# SERVICE BULLETIN

## Replacement of oil pump housing for ROTAX® Engine Type 915 i A and 915 i B (Series)

ATA System: 79-20-00 Oil pump assy.

Fig. 6

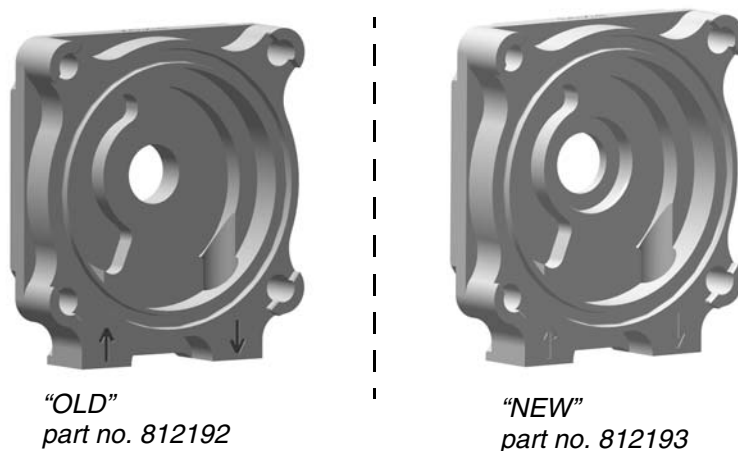
**3.3) Preparation of oil pump housing**

Oil pump housing:

*Fig. 7*

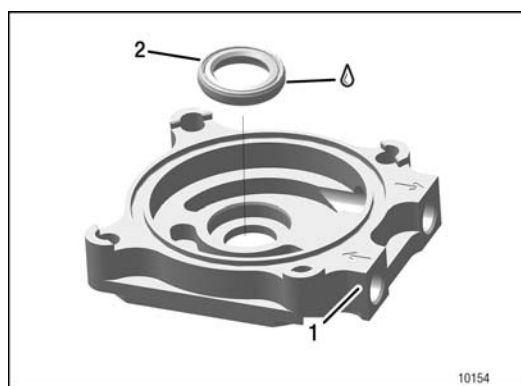
Step	Procedure
1	Place new oil pump housing (1) with rotor cavity and seal cavity facing upwards on a clean, flat surface. NOTE: Do not damage rear sealing face of oil pump housing.
2	Lubricate the sealing lip and circumference of oil seal (2) with engine oil and place with closed face upwards into oil seal cavity.
3	Tap the seal into place using a rubber mallet.

NOTE: Oil seal already installed in the new oil pump housing (part no. 812193) supplied with the kit part no. 481550.

Fig. 8

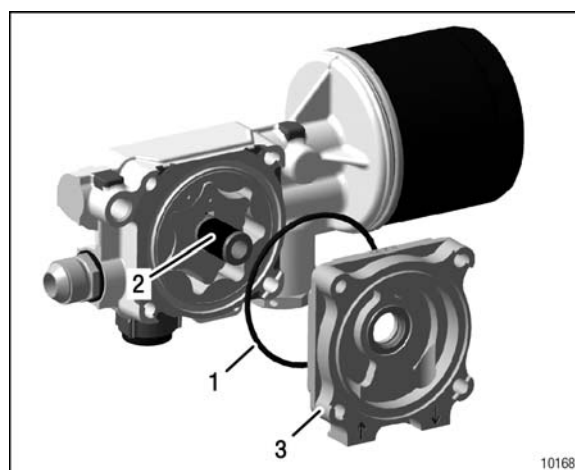
Step	Procedure
1	Place new O-ring 63-2.5 (1) into the oil pump housing (3).
2	Wrap tape over the oil pump shaft (2) to protect the oil seal.
3	Apply engine oil to the oil pump shaft. Place oil pump housing (3) with seal installed over oil pump shaft (2), while turning it slightly.
4	Check if the oil seal lip is seated correctly.
5	Remove the tape from the oil pump shaft (2).

Fig. 14

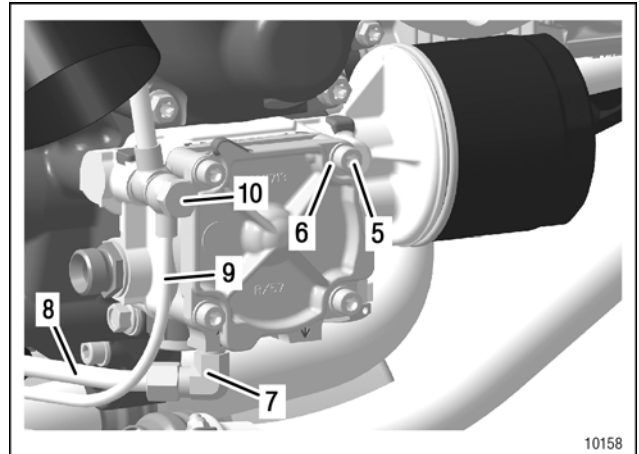
Step	Procedure
2	Install the oil pump housing with Allen screws M6x50 (5) and washers 6.4 (6) crosswise and by hand. Then tighten the Allen screws crosswise. Tightening torque 10 Nm (89 in. lb).
3	Coat the threads of turbo oil suction elbow (7) with LOCTITE 243 and screw into oil pump housing until tight and aligned with turbo oil suction line (8). Tighten torque 12 Nm (106 in. lb). NOTE: Elbow threads are tapered, do not over-tighten or oil pump housing may be damaged.
4	Attach turbo oil suction line (8). Tighten torque 15 Nm (133 in. lb).
5	Connect the turbo pressure oil line (9) (turbo and governor) using banjo bolt M10x1x30 (10) and new sealing rings. Tightening torque 12 Nm (106 in. lb).
6	Re-install the cable clamps.
7	Clean up any residual oil and degrease area to allow proper leak inspection.
